**Proposed Plan
for Soil, Sediment, and Surface Water
at RVAAP-40 Load Line 7**

**Former Ravenna Army Ammunition Plant
Portage and Trumbull Counties, Ohio**

Attachment 1.	Ohio EPA Comments and Responses
---------------	---------------------------------

Figure 5. PAH Exceedances of FWUG in Surface Soil (Source Area ISM Samples)

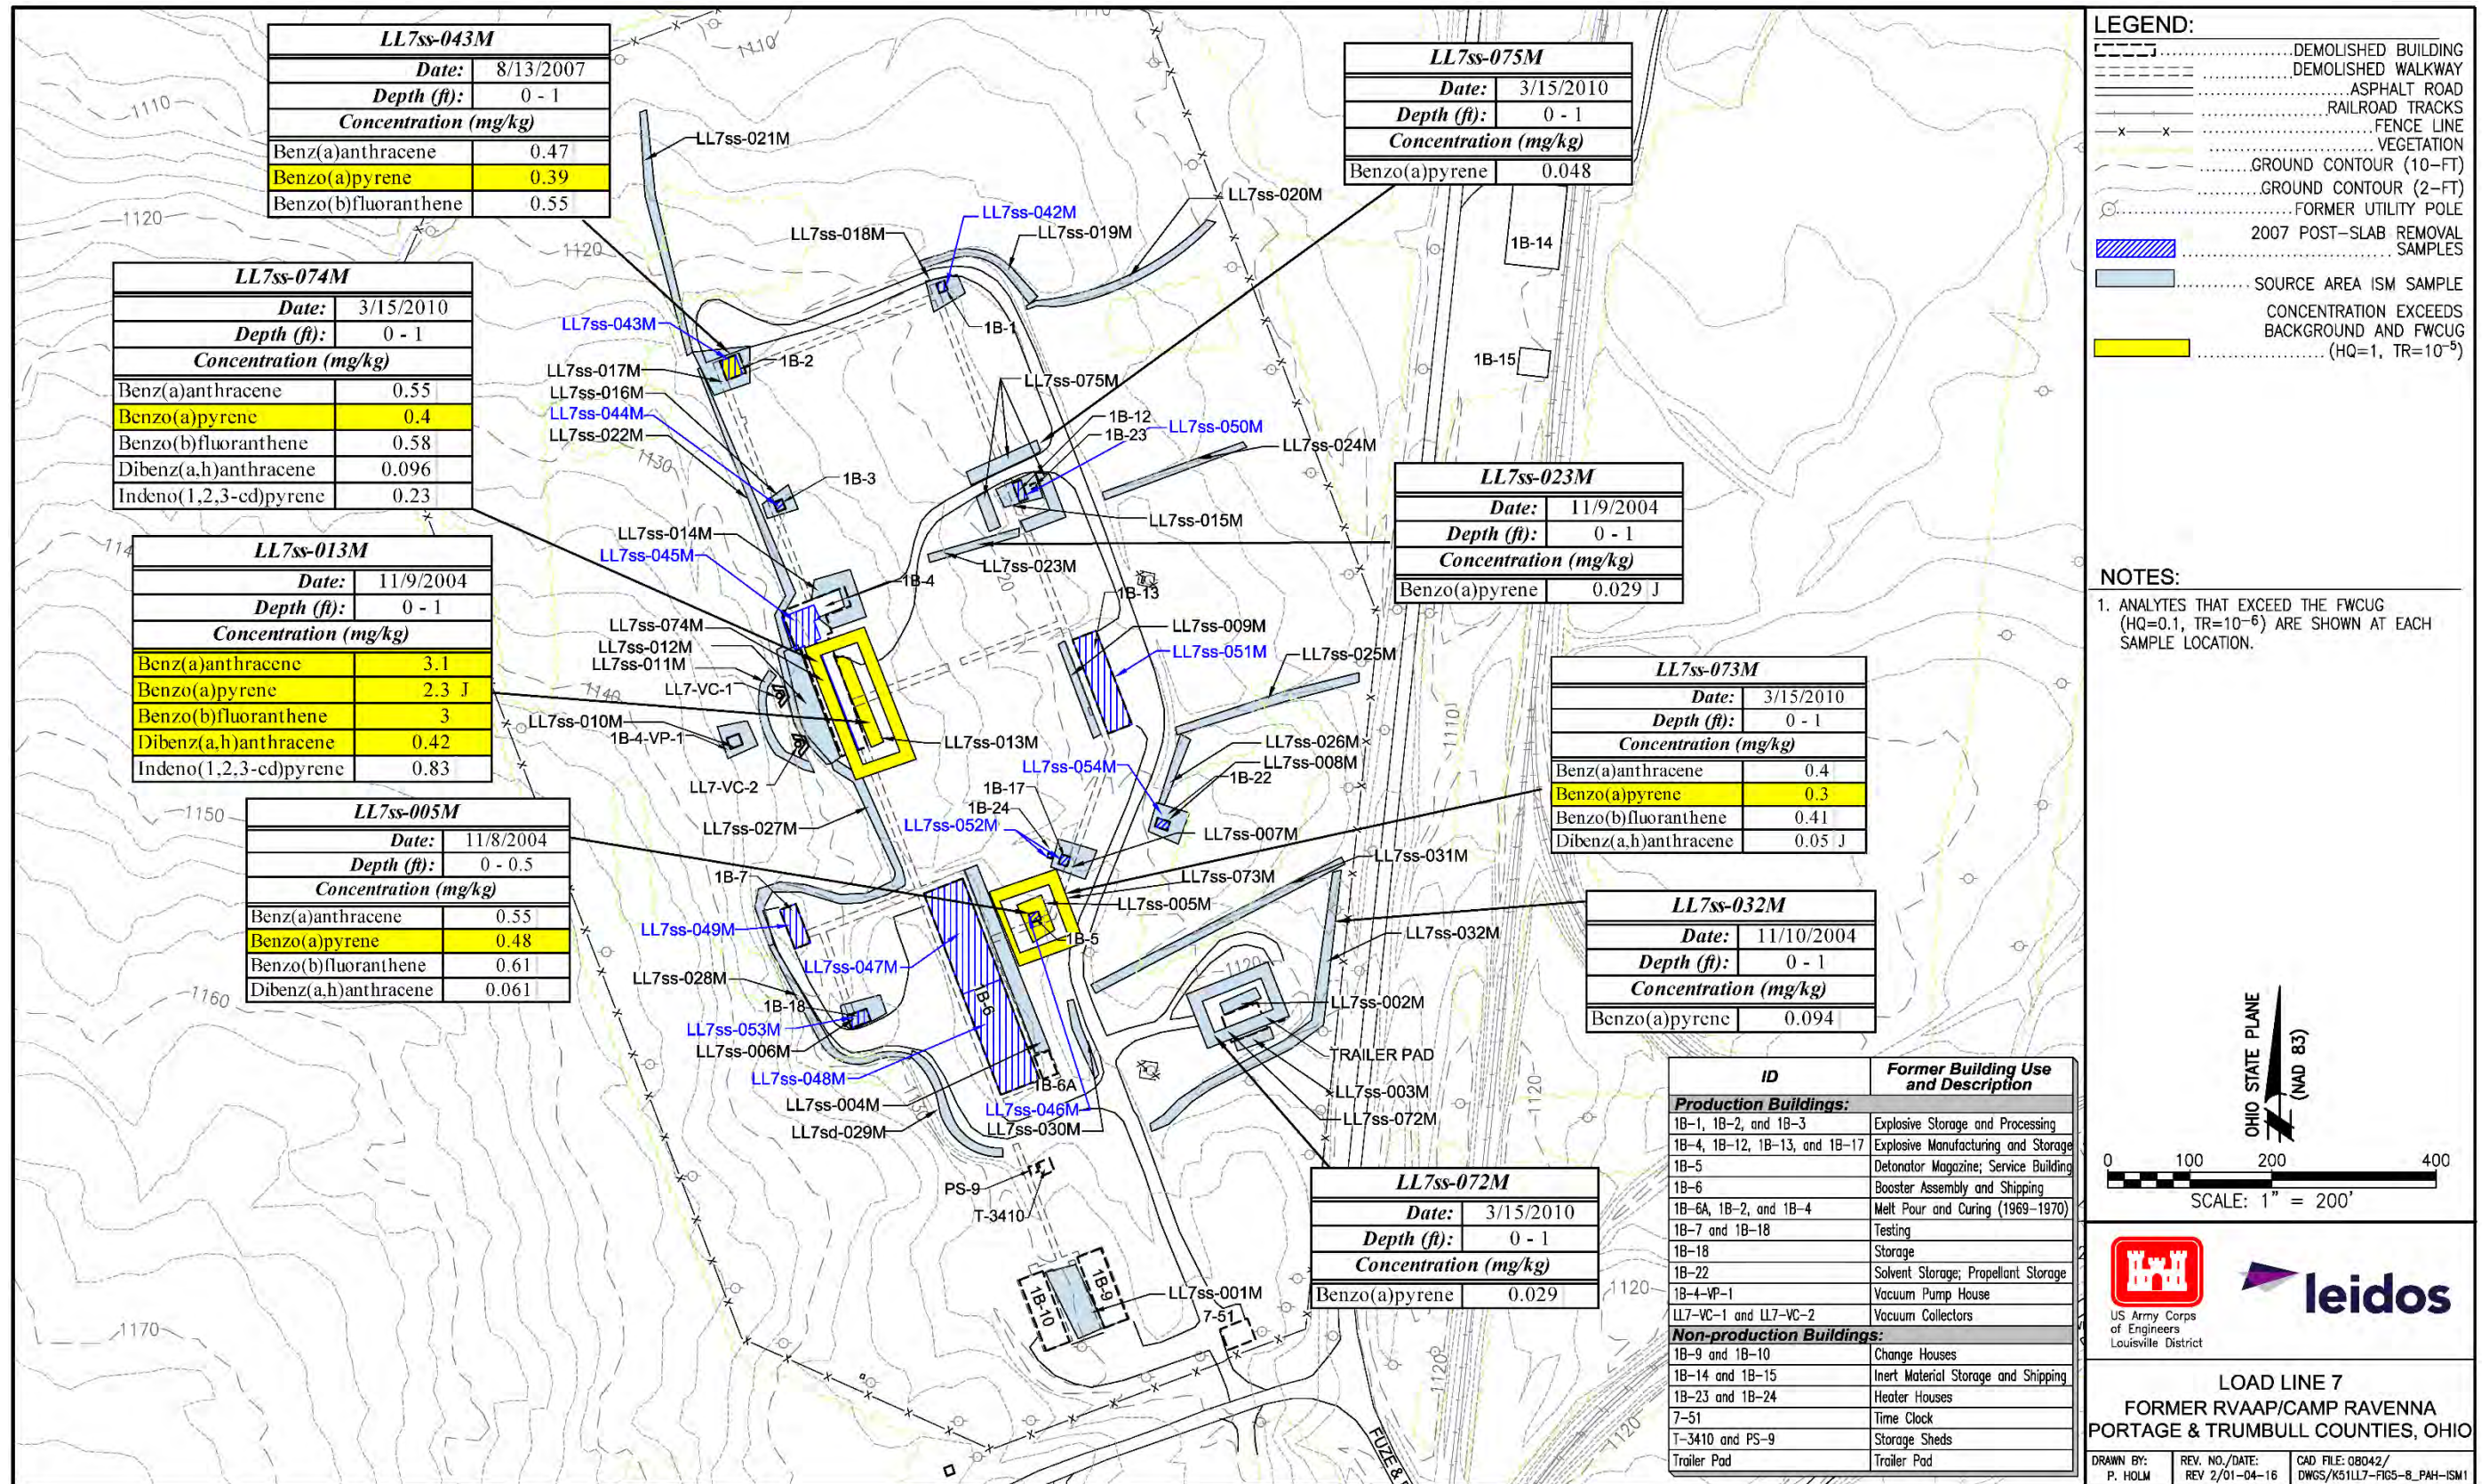
Regarding comment #2 requesting additional maps: Ohio EPA requested Figures 5-8, 5-10 and 5-11 be added to the Proposed Plan for clarification. The author of the Leidos response letter agreed, although only figures 5-8 and 5-11 (and not figure 5-10) were added. Upon consideration, this acceptable to Ohio EPA.

- 2) As the Polynuclear Aromatic Hydrocarbon (PAHs) are proposed for remediation at LL-7 and are focused in the Draft PP. It would be helpful to add additional figures from the Final Remedial Investigation/Feasibility Study (RI/FS) report regarding PAHs to the PP, for clarification purposes. Some of the original ISM sampling areas were resampled with new redrawn boundaries that may have used a combination of the following: (1) included some of the original ISM sample area, (2) eliminated some of the original area, (3) included a portion of another original ISM area, or (4) included an area not previously sampled. The ISM resample area results were then evaluated and either eliminated or moved forward for evaluation in the FS for remedial activities. Although the PP text presents the sample identification number not all corresponding PAH concentrations are provided. Ohio EPA suggests Figure 5-8 (PAH exceedances in surface soil), Figure 5-10 (PAH exceedances in discrete/subsurface soil samples), and Figure 5-11 (Concentrations of PAHs Near LL-7ss-013M from April 2011 Sampling Event) be included in the PP. These Figures clearly present the sampling locations, concentrations, eliminated areas, and designated areas moved forward for remediation activities in a logical progression that supports the text in the PP.

Army Response: Agree. As surface soil COCs (PAHs) are discussed in the Proposed Plan, the Army agrees to include figures pertaining to the surface soil sample results presented in the RI/FS Report (figures 5-8 and 5-11). The figure list will now be as follows:

- Figure 1. General Location and Orientation of Camp Ravenna
- Figure 2. Location of Load Line 7 at Camp Ravenna
- Figure 3. Load Line 7 Site Features
- Figure 4. Load Line 7 Sample Locations
- Figure 5. PAH Exceedances of FWCUG in Surface Soil (Source Area ISM Samples) ~ *figure 5-8 of RI-FS Report*

The HHRA identified four PAHs in surface soil (0–1 ft bgs): **benz(a)anthracene, benzo(a)pyrene, benzo(b)fluoranthene, and dibenz(a,h)anthracene**. As shown on Figure 5, locations LL7ss-005M, LL7ss-013M, LL7ss-043M, LL7ss-073M, and LL7ss-074M had an exceedance of at least one Resident Receptor FWCUG in surface soil.
